## **SWEENEY BLOCKS**

4440 FAUNTLEROY AVE SW, SEATTLE WA 98126  
SDCI Project #3035693-LU | RECOMMENDATION | Meeting Date: November 18, 2021

1. TRANSITION POINTS

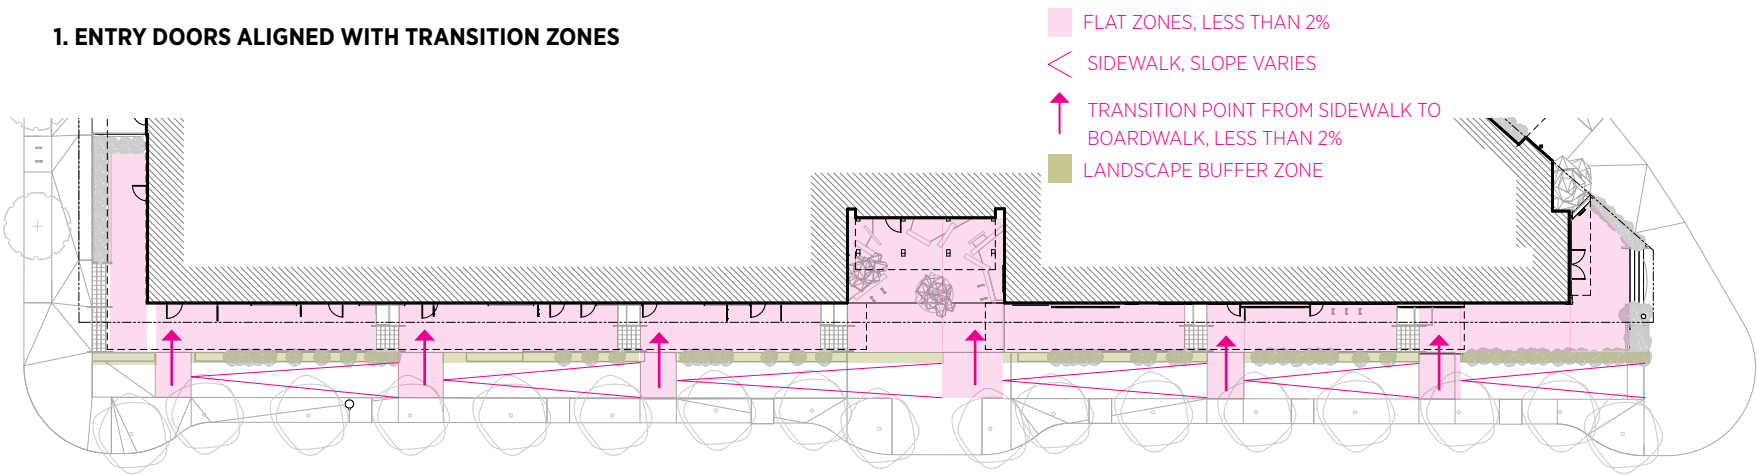
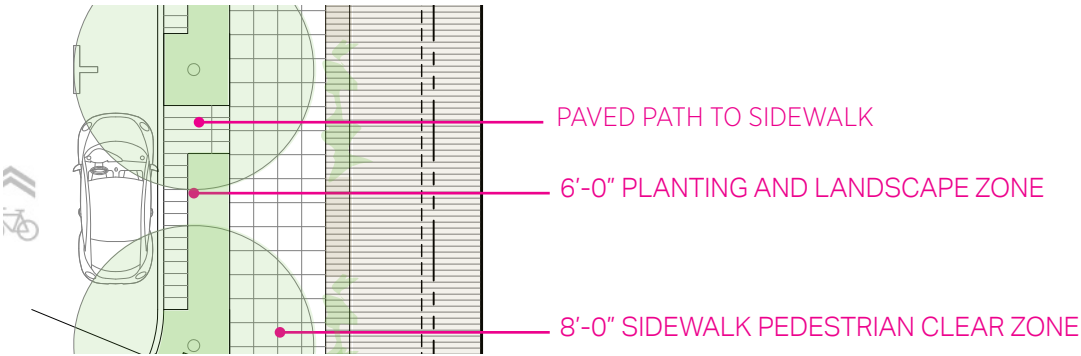
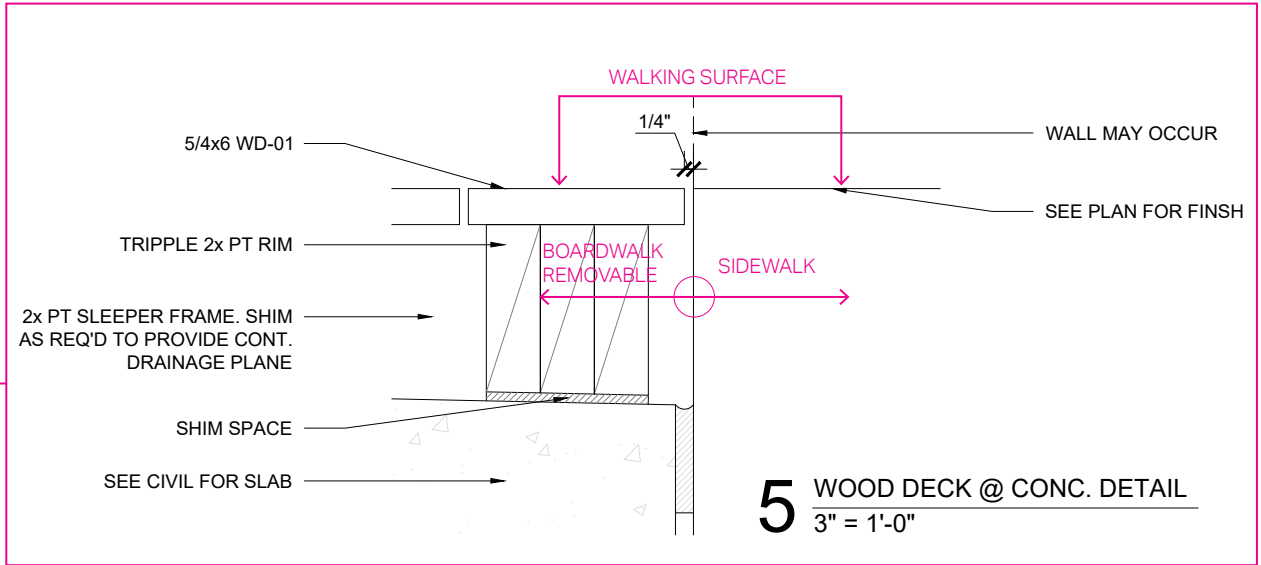
b. Agreeing with public comment, the Board was supportive of the ‘boardwalk’ concept, however, the Board requested an accessibility study be included at the Recommendation phase to demonstrate how the ‘boardwalk’ concept will be accessible to everyone. (PL2.A)

The design team engaged Studio Pacifica to consult on ways to make the streetscape accessible and welcoming to all. After an initial meeting Studio Pacifica made the following recommendations:

- The slope of the sidewalk and the boardwalk level out at various intervals along 36th. These transition points must be carefully considered.
- AMA & KPFF (Civil) will work together to ensure the running slope and the cross slope are resolved to create areas with less than 2% slope a the transition points.
- The transition from the side walk to the boardwalk should have a smooth uninterrupted walking / rolling surface.
- Transition points should be aligned with Retail entries where possible.
- Transition points should be highlighted with focused signage and lighting to indicate main retail access.

The boardwalk access stairs should be revised with the following considerations:

- The stairs should align with the path of circulation and be distinct from the “café/ furniture” zone.
- The stairs should be narrowed and have handrails on both sides.
- Path of circulation may be either on the inside or the outside of the boardwalk, but should be clearly defined.
- The furniture zone should be flexible and accommodate a range of users.
- Stairs should be illuminated with step lights, under rail lights or other lighting system to accommodate reduced-vision users.

- While everyone agrees that the wood-look boardwalk supports the over-all concept of the site, the design team needs to pay careful attention to the material selected, the transition details, the stability of the walking surface, and the gap space between the decking members.

- The street parking stalls, whether back-in angled parking or parallel need to have periodic paved transitions to the sidewalk.

4 FENESTRATION BAYS

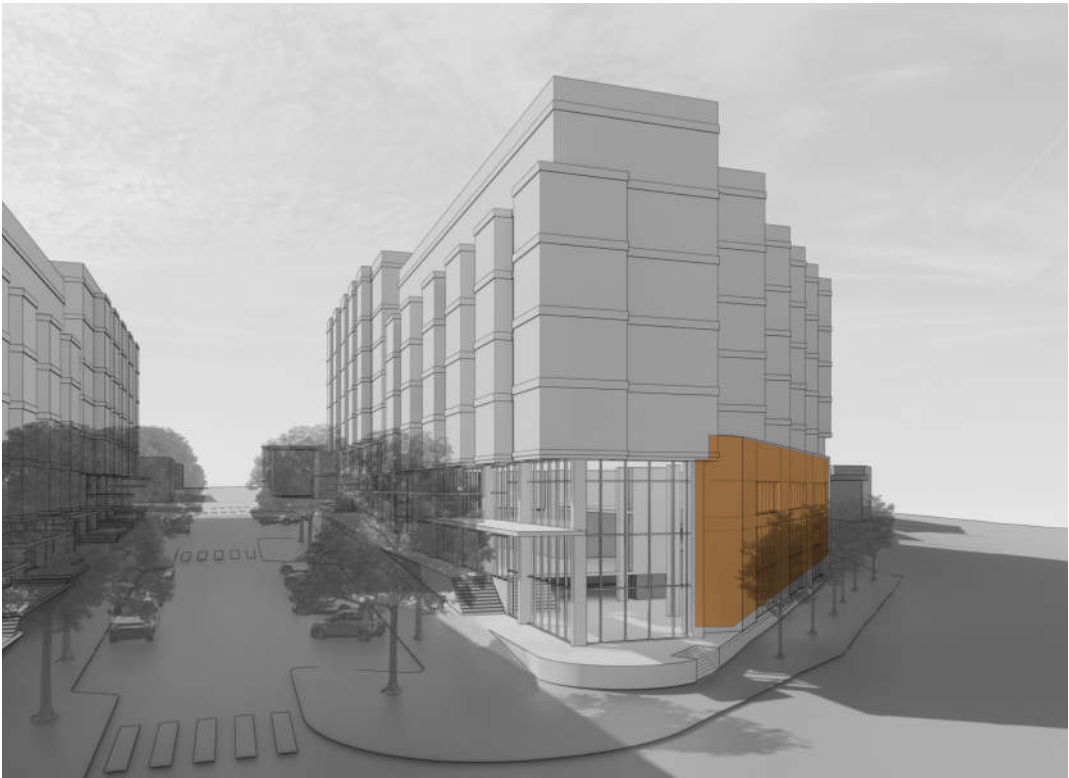
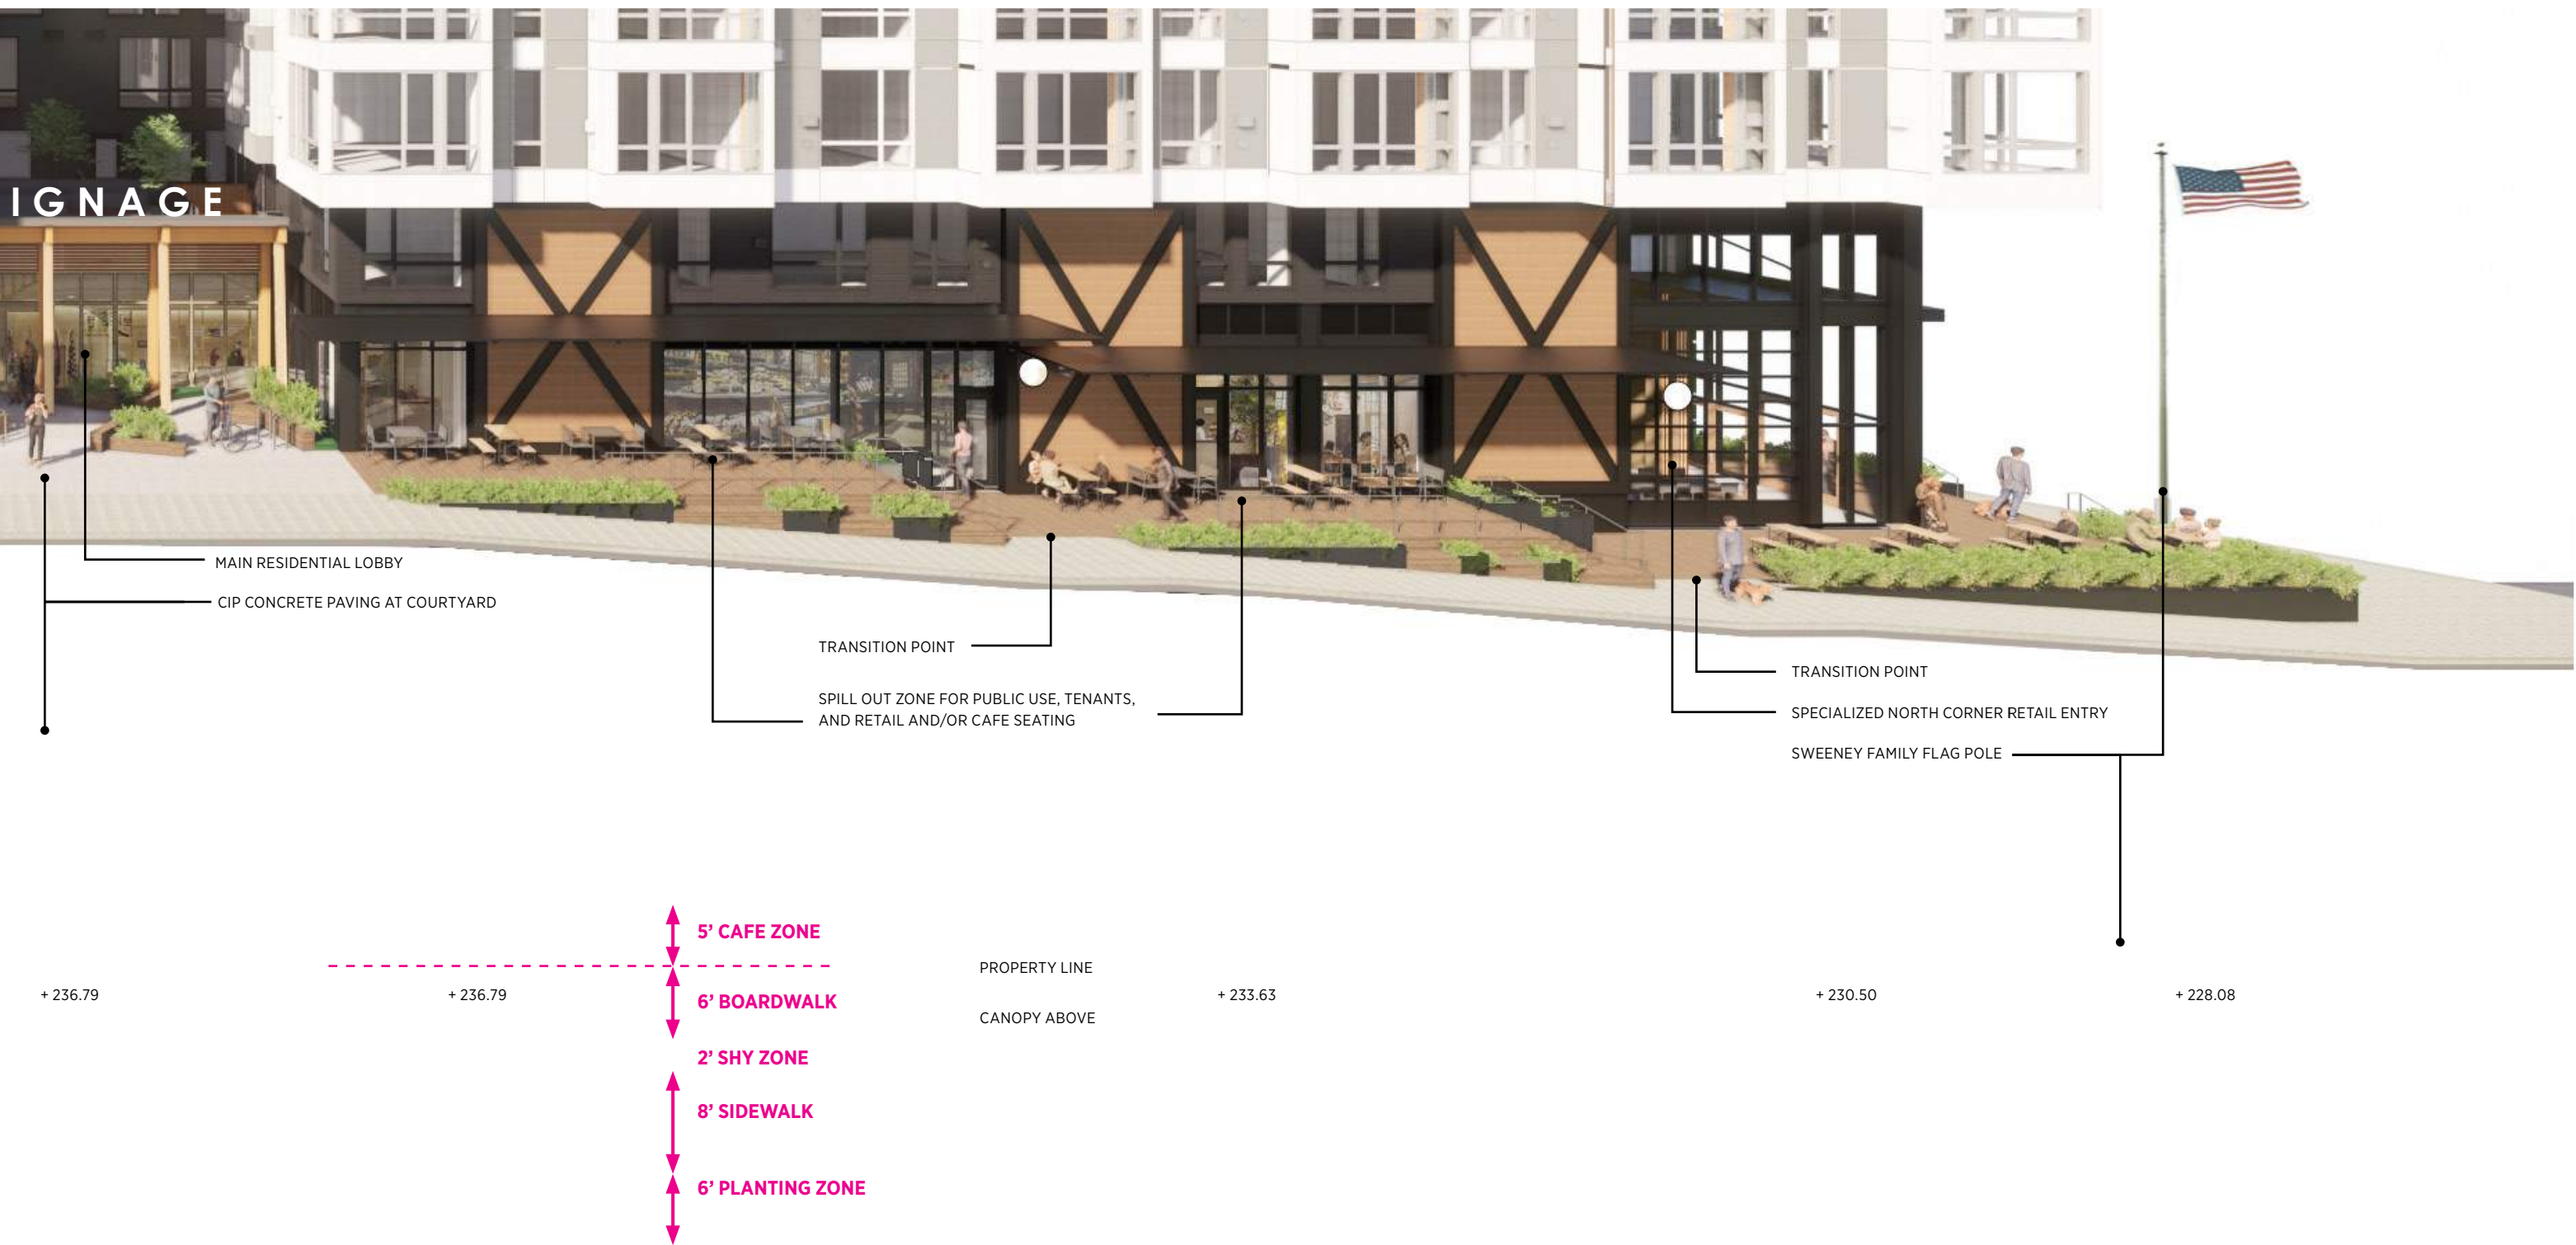
c. The Board encouraged the applicant to introduce more building modulation at street level, expanding the street canopy, and landscaping at the street level and along the west side of the building. The Board members noted that the upper floors include a lot of moves and interest; the street level should also have a similar treatment.

The design team still feels a solid base along the west side of the site is the right move. It creates a feeling of stability adjacent to the busy flow of traffic along Fauntleroy and provides a streamlined base in contrast with the exaggerated upper level massing and modulation. To respond to the Board’s guidance the design team has made the following improvements:

- Fenestration bays increased from 3 to 4
- Fenestration bays inset 2’
- Added street level planting
- Added parapet planting
- Added canopies
- Added specialty retail signage
- Added decorative and functional lighting

CURRENT CORNER OF OREGON & 36TH

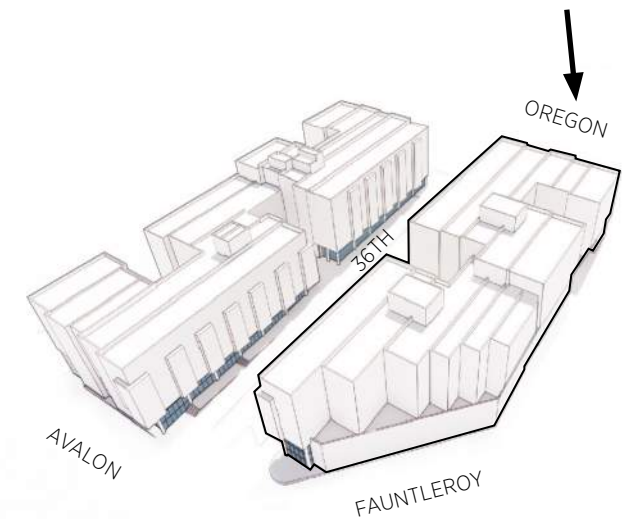
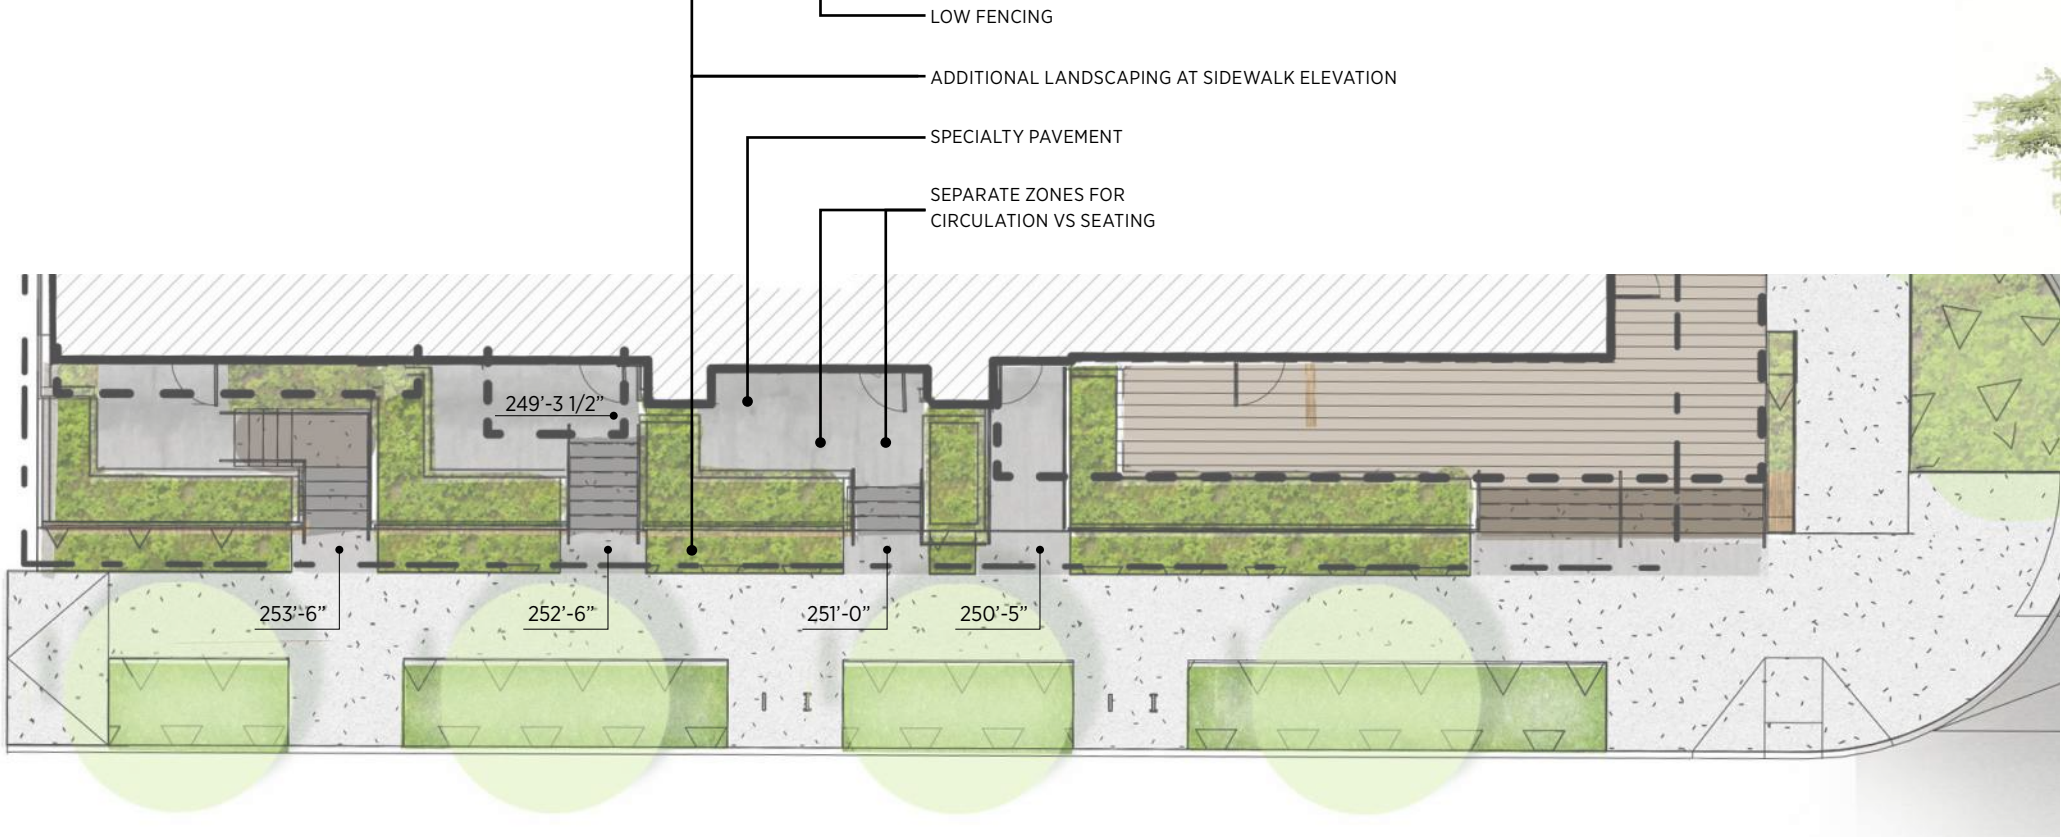
d. Along the south building facade facing Oregon Street, the Board expressed concerns about a lack of an entry sequence from the sidewalk to the unit doors. The Board requested the applicant address this by establishing a hierarchy of entry details from the sidewalk to the front door of the ground level units. The Board members requested that safety factors be considered in light of introducing more landscaping. While landscaping may be appropriate, the Board directed the applicant to study the introduction of a landscaping element that would create a distinct entry from the sidewalk and not introduce a potential safety and security issue.

The unit entry sequence along Oregon has been updated and enhanced with the following design elements:

- Additional landscaping is provided at the sidewalk elevation to buffer the sidewalk from the unit patios.
- Low fencing has been added to provide a sense of privacy while maintaining sight-lines for security.
- Separate zones for circulation vs seating
- Specialty pavement to differentiate sidewalk from patio.

SECTION - ALLEY FACING UNIT

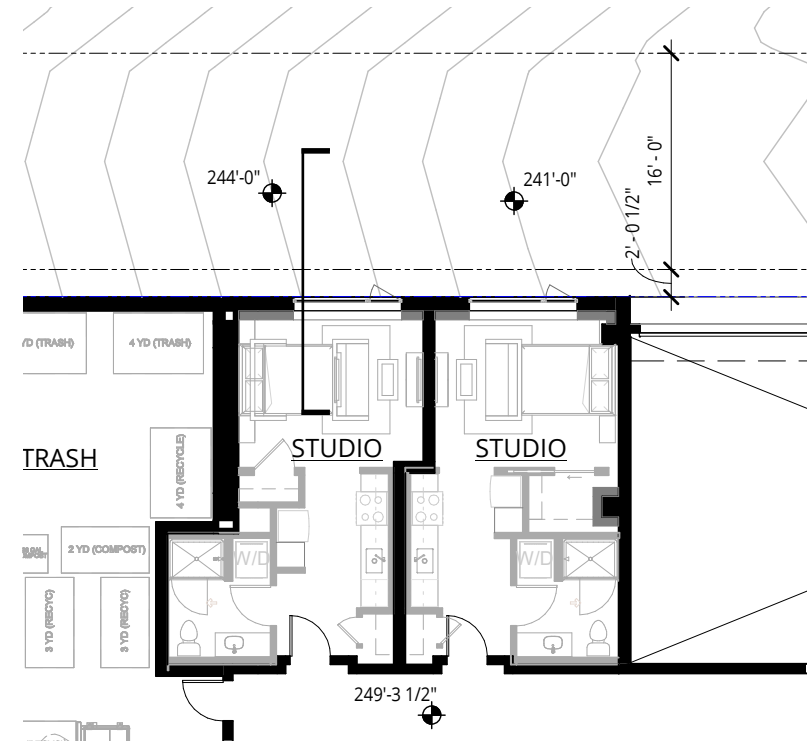
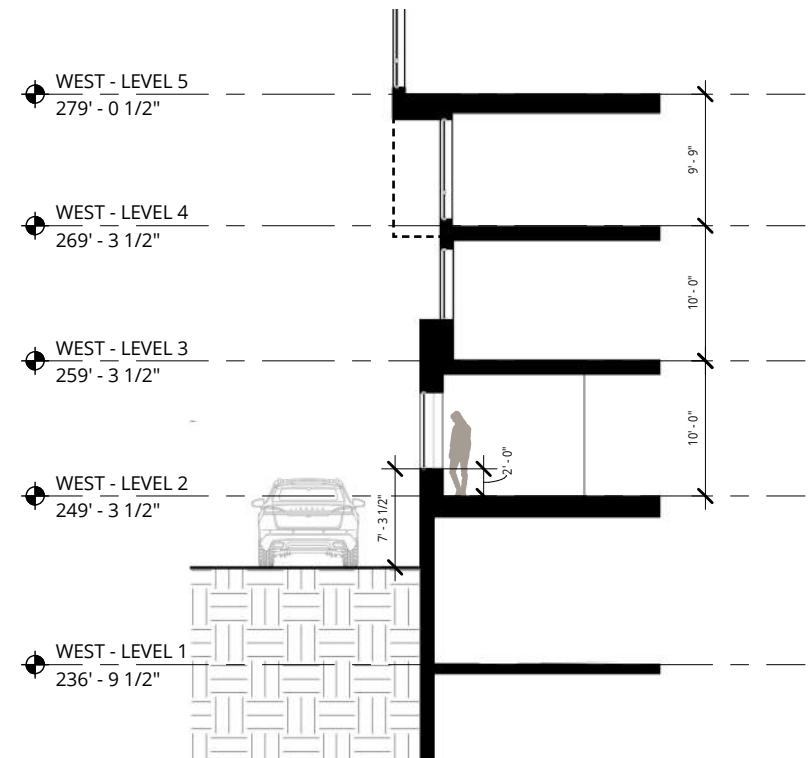
a. The Board expressed concerns with the building’s interface with the alley side (west side) of the site. The concerns focused on the two alley-side residential units and the presence of the west facing facade on Fauntleroy Way. The Board requested details at the Recommendation phase to include a material and composition study of the west facade due to its visibility from Fauntleroy Way. For the two residential units on Level Two along the alley, the Board’s noted that the units were located in an area that appeared rather hostile for future residents. The Board requested the applicant include a study of how to soften the edge of these two units along the alley. The Board suggested introducing landscaping, balconies, and additional setbacks for these units to provide relief from being located right at the alley line.

The design team is proposing board-formed concrete finish for the base of the Fauntleroy side of the building wrapping into the alley. Board-formed concrete gives the durability required along Fauntleroy and the alley while supporting the overall material concept of the project. The window sills of the units facing the alley have been raised to be 2’ above finish floor to mitigate the impact of sound and light from alley traffic.

The project team has recently received a Variance from SDOT to reduce the required height above the alley dedication. This will greatly simplify the structure of the building, while maintaining the same massing concept. The inset “gasket” between the upper massing and the podium will remain.
